STAFF REPORT

TO: City Council
FROM: Sophia Jensen, City Planner
AGENDA ITEM: Upper 33rd Street N Conditional Use Permit Request
REVIEWED BY: Ben Hetzel, Prior City Planner

Re: Upper 33rd Street North Townhouse CUP
Site Plan review
PID 1302921320052 & 1302921320051

Sheet Title:
GRADING AND EROSION CONTROL PLAN

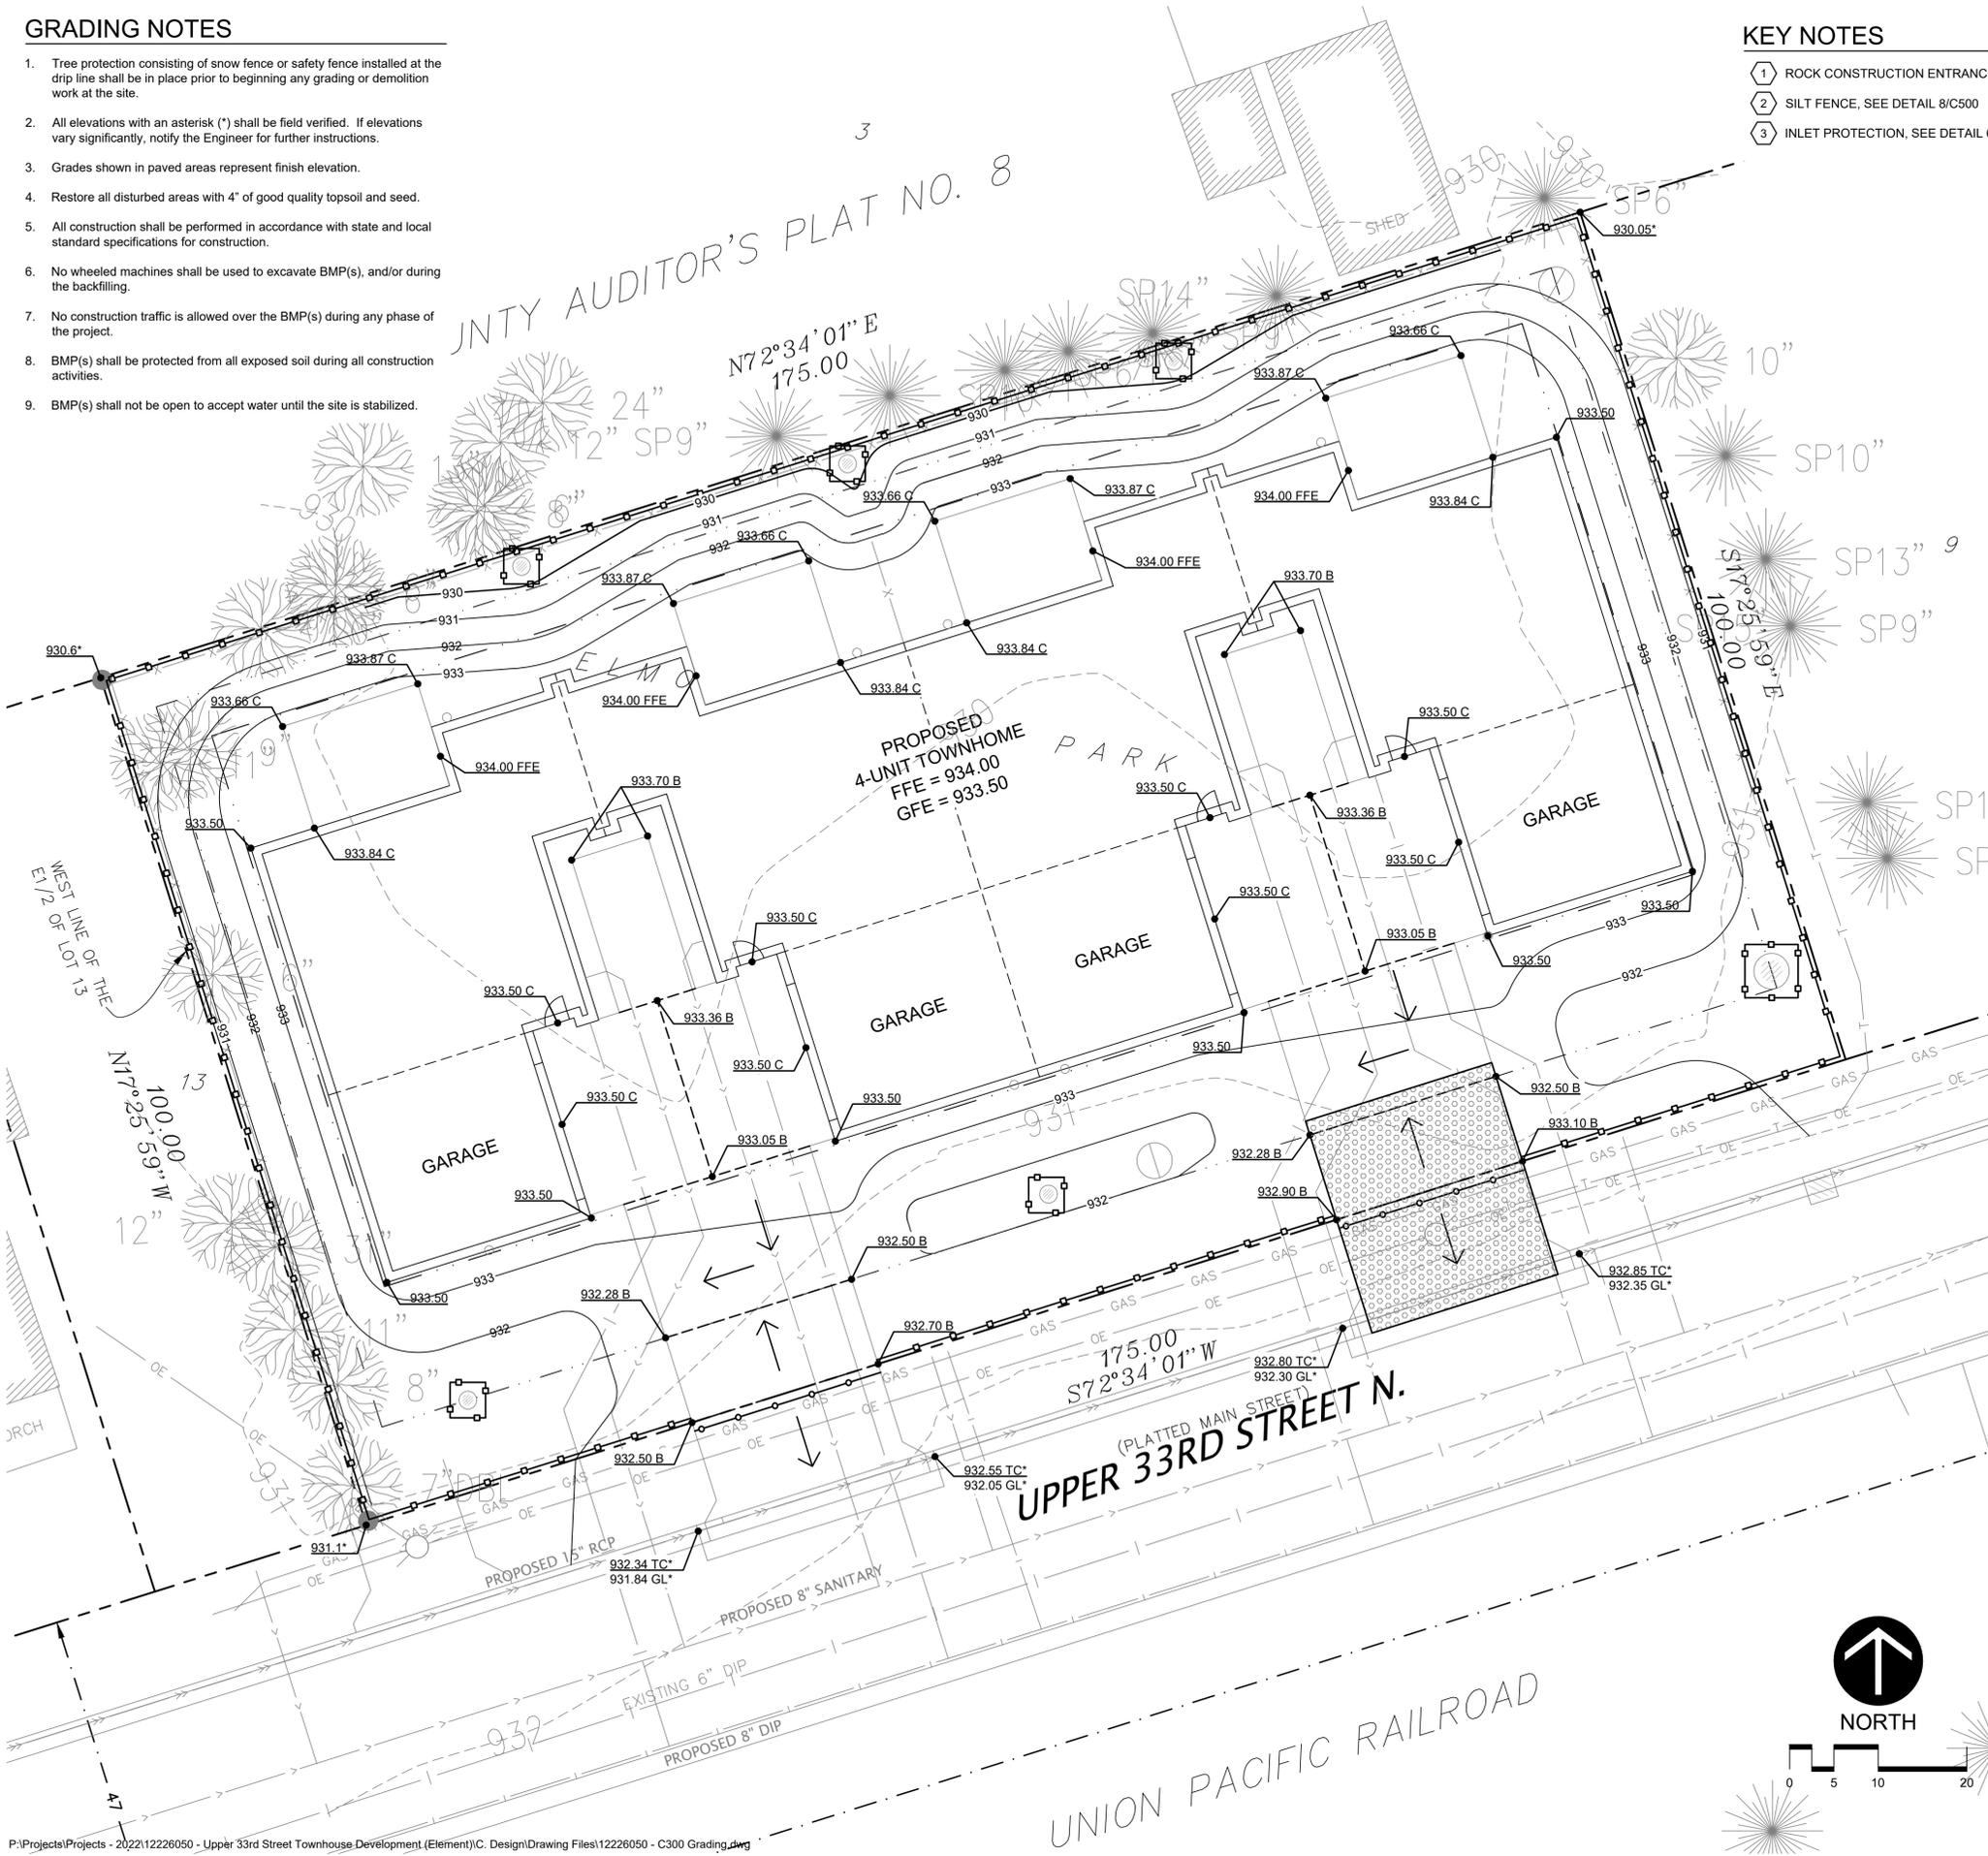
8. Site grading must be revised to meet all city minimum and maximum allowable grades. The right-of-way boulevard must be a minimum 4% grade and all other site grades must be a minimum of 2% grade. Rear yard grades must be labeled 3:1 maximum.

9. Site grading must be revised to show the 100-year HWL storm event elevation (and 100-year HWL contour) for all low points on the site. The grading plans must also show all discharge locations from the property, including emergency overland overflow locations and EOF elevations. The grading plans must be revised, as may be required, to meet city design standards for flood protection, requiring 2-feet of vertical separation to all adjacent building low floor elevations from any low area 100-year HWL, and requiring 1-foot of vertical separation from any emergency overflow elevation to all adjacent building low opening elevations.
